INTRODUCTION

Chrysler A604

CHRYSLER A604 NEW 4 RING STATOR

Figure 34

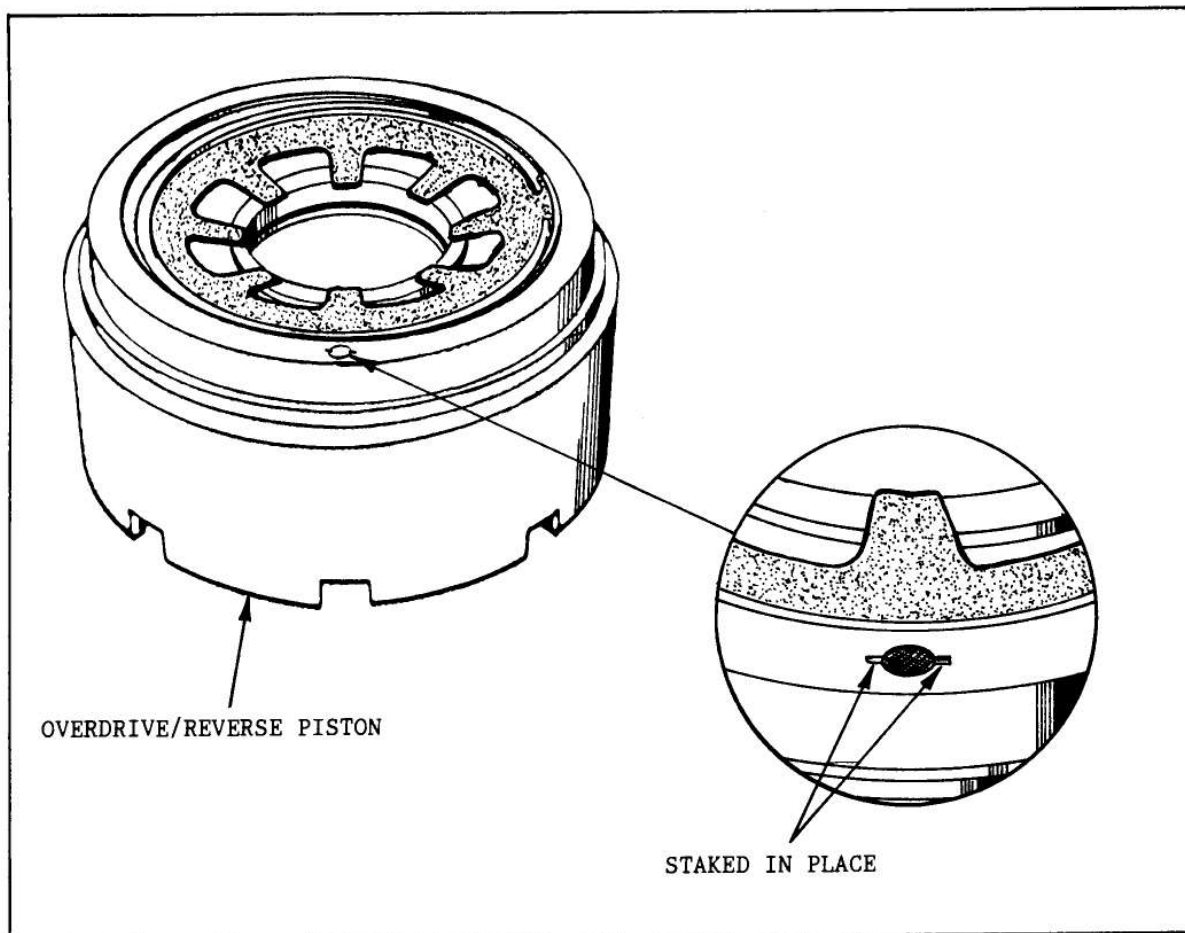
COMPLAINT: Premature failure of the overdrive and the reverse clutch plates, and all lip seals and "O" rings are good.

CAUSE: The cause may be an orifice and screen assembly blown out of the overdrive/reverse piston (See Figure 34).

CORRECTION: Replace the Orifice/Screen Assembly with a new one, available under OEM part number 4531903, and stake the new assembly in place (See Figure 34). They were not all staked in place at the factory.
